Oregon State University  
Construction Contracts Administration  
Gill Coliseum Men's Basketball Locker Room Renovation

ADDENDUM NO. 4

## ADDENDUM # 4

# OSU GILL COLISEUM MEN'S BASKETBALL LOCKER ROOM REMODEL

**1** ENLARGED PROPOSED FLOOR PLAN - PLUMBING  
 P1.3 SCALE: 1/4" = 1'-0"  
 0 2' 4' 8'

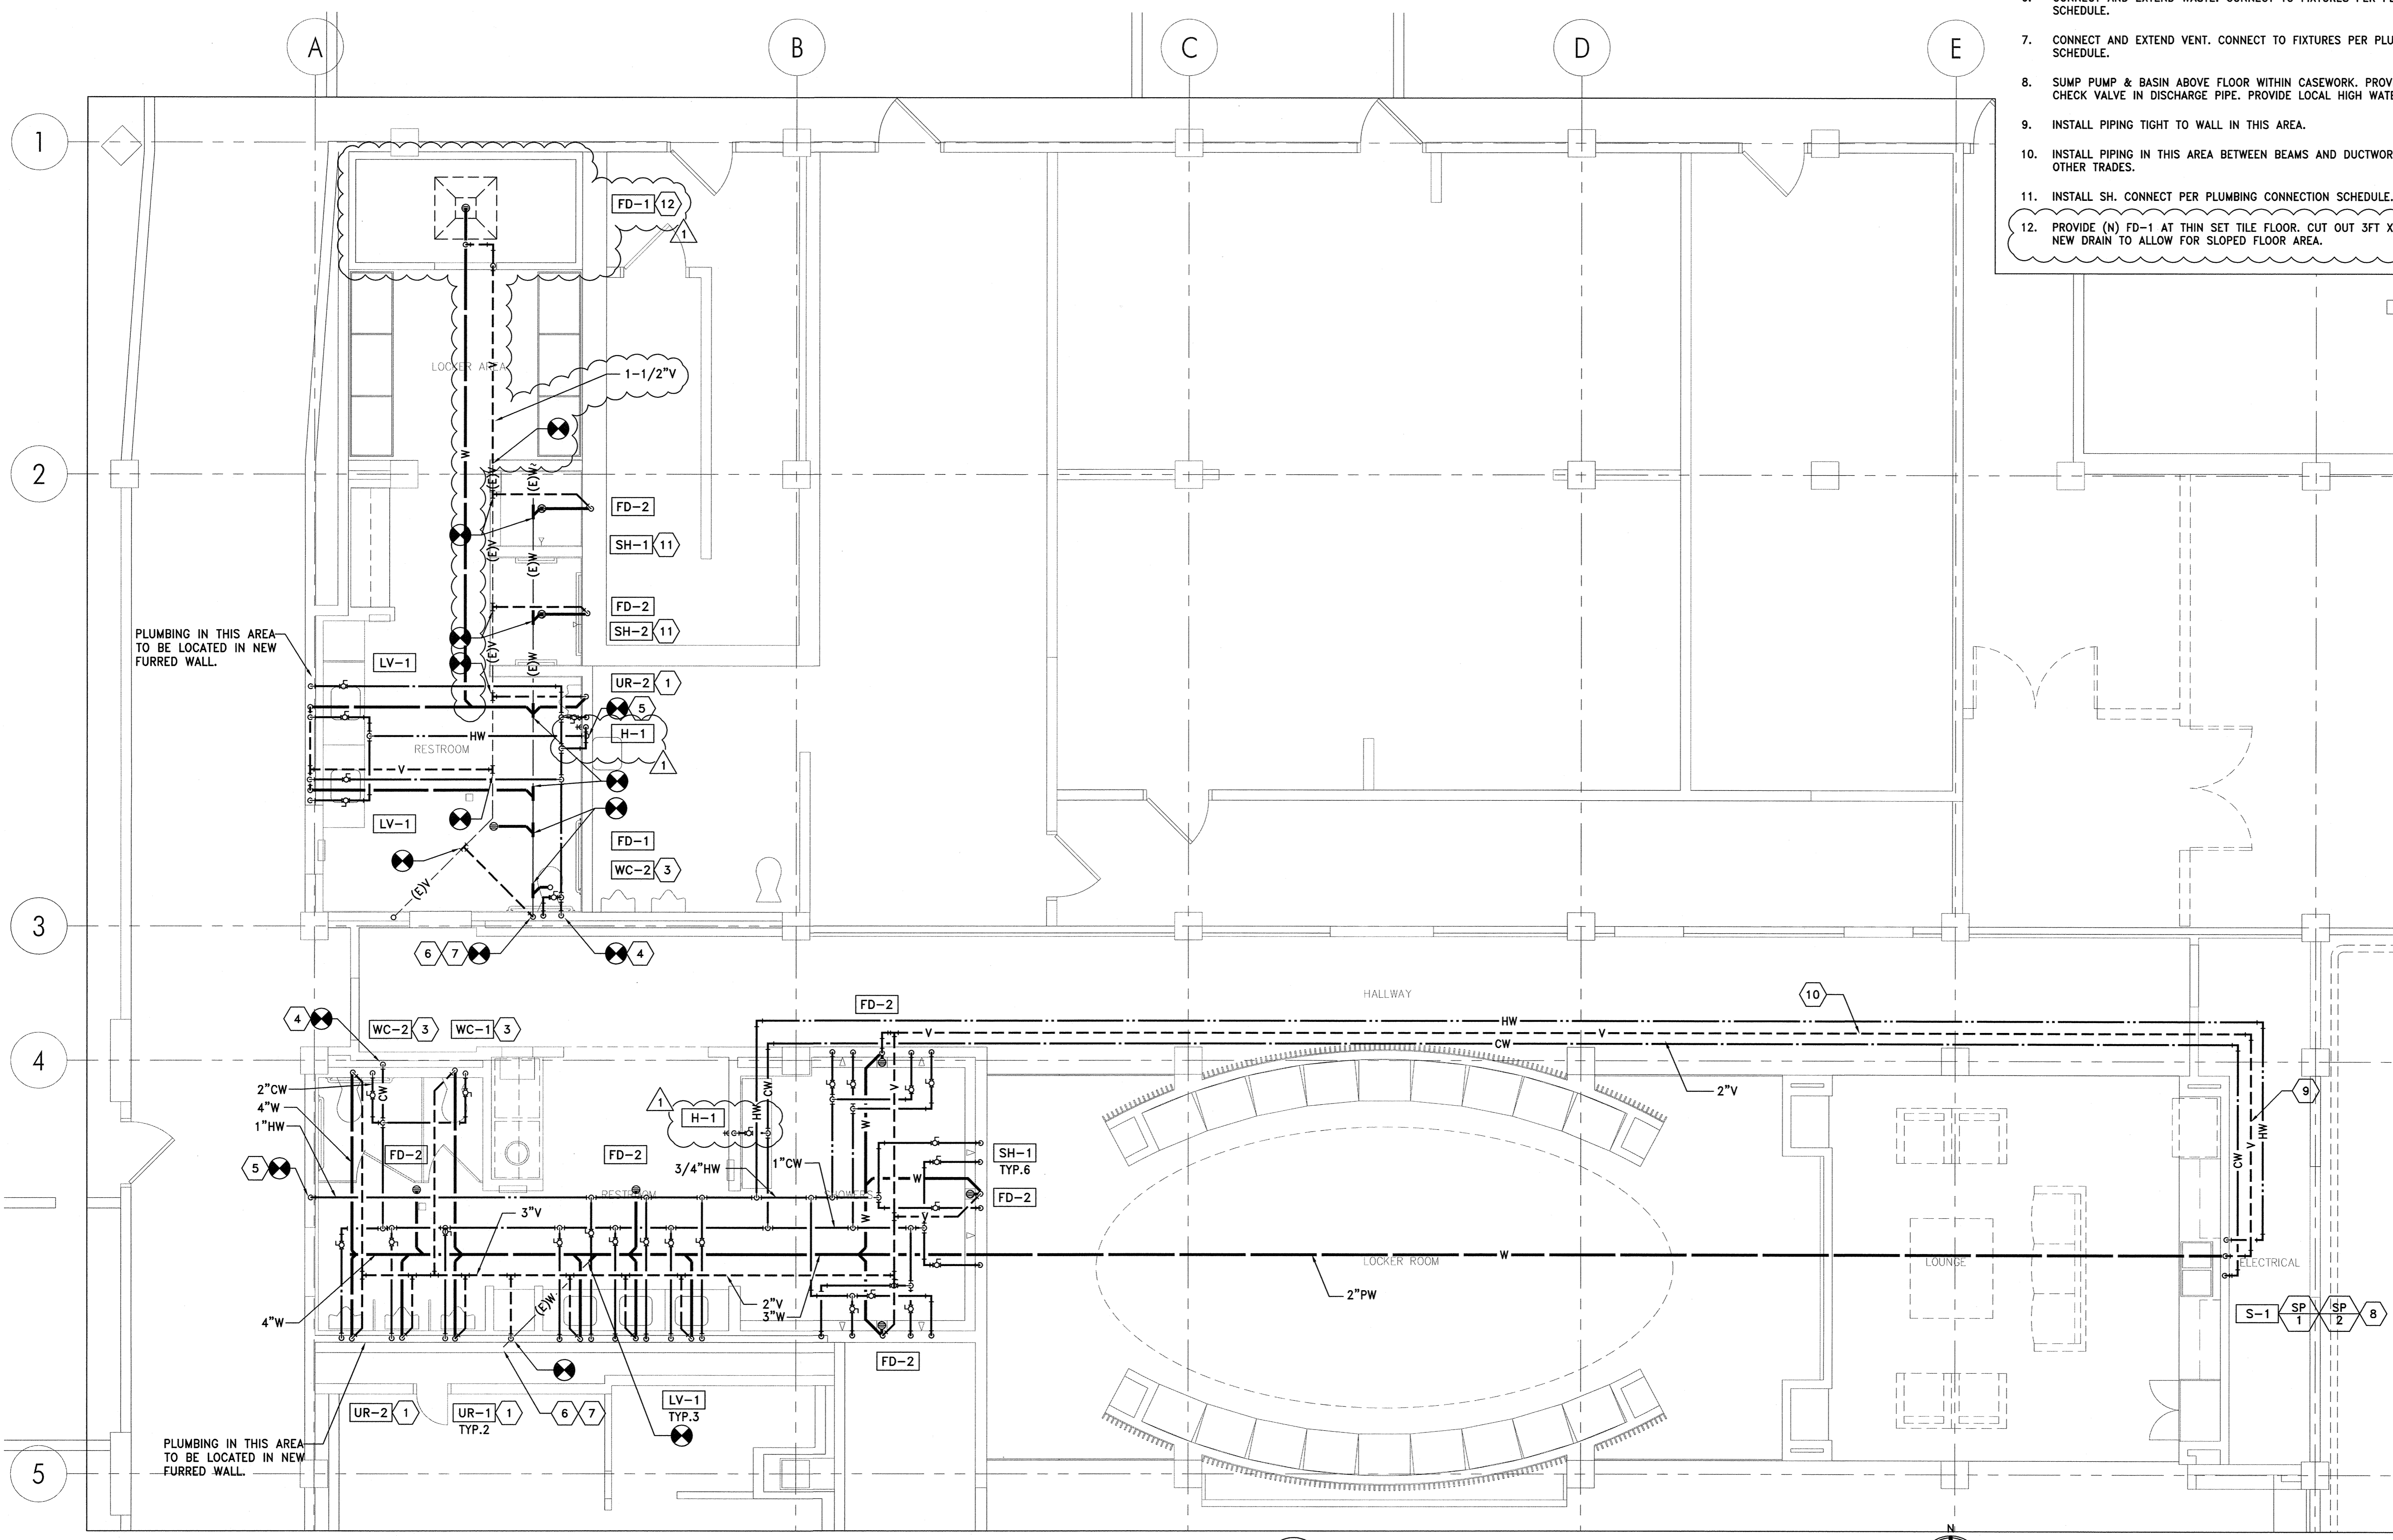
##### *Sheet P1.3*

- B. ADD floor drain FD-1 and associated piping for sauna at Coach's Lockers 102.

- C. **ADD** hose bibb HB-1 and associated piping Coach's Restroom 101 and Player's Restroom 103.

10. INSTALL PIPING IN THIS AREA BETWEEN BEAMS AND DUCTWORK. COORDINATE WITH OTHER TRADES.
  11. INSTALL SH. CONNECT PER PLUMBING CONNECTION SCHEDULE.
  12. PROVIDE (N) FD-1 AT THIN SET TILE FLOOR. CUT OUT 3FT X 3FT AREA FOR NEW DRAIN TO ALLOW FOR SLOPED FLOOR AREA.
